# UNITED STATES PATENT AND TRADEMARK OFFICE

10/664,371

Jorge L. Orbay

<b>Office Action Summary</b>	<b>Application No.</b> 10/664,371	<b>Applicant(s)</b> ORBAY, JORGE L.	
	<b>Examiner</b> Anu Ramana	<b>Art Unit</b> 3775

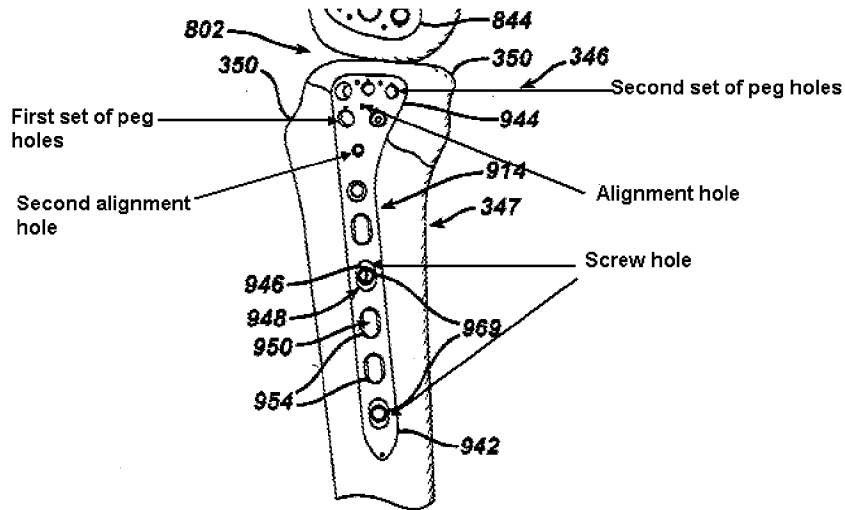
Claims 37-38, 40-43, 45-46, 48-51, 53-55, 58, 65-69, 82 and 83 are rejected under 35 U.S.C. 102(e) as being anticipated by Wack et al. (US 2004/0030339 A1).

Wack et al. disclose a plate 914 defining a first set of peg holes structurally adapted to engage a threaded head of a fixation peg and at least one non-threaded alignment hole or k-wire hole sized to receive a k-wire, the alignment hole having a second small diameter relatively smaller than each of the peg holes in the first and second sets wherein at least one alignment hole is entirely within the boundaries defined by tangent lines to adjacent peg holes (Figs. 20-22 and paras [0118]-[0162]). See a portion of Fig. 20 marked up to show features of Applicant's invention on the following page.

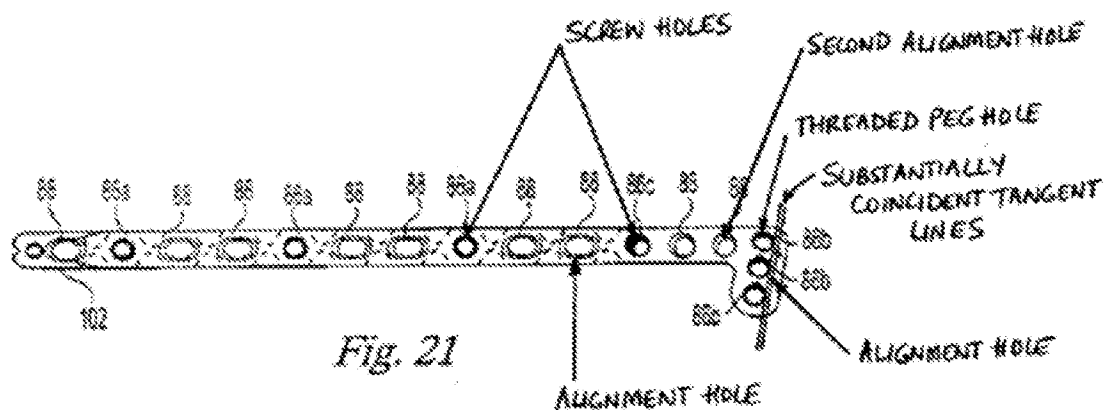
Claims 37-38, 40-41, 45-48, 51, 53-55, 82 and 83 are rejected under 35 U.S.C. 103(a) as being unpatentable over Weaver et al. (US 6,623,486) in view of Procter et al. (US 5,527,311).

Weaver et al. disclose a bone fixation plate 80 including: a head angled relative to a the shaft; the head portion defining a first set of threaded holes 86b; alignment holes much smaller in diameter than the threaded holes for provisional fixation of the bone plate; a second alignment hole 88; and a plurality of screw holes 86a in the shaft of the bone plate (Figs. 20-26, col. 6, lines 58-67 and col. 7, lines 1-17). See marked up Fig. 21 from Weaver et al. on the following page.

Weaver discloses all elements of the claimed invention except for an alignment hole located entirely between two immediately adjacent peg holes.
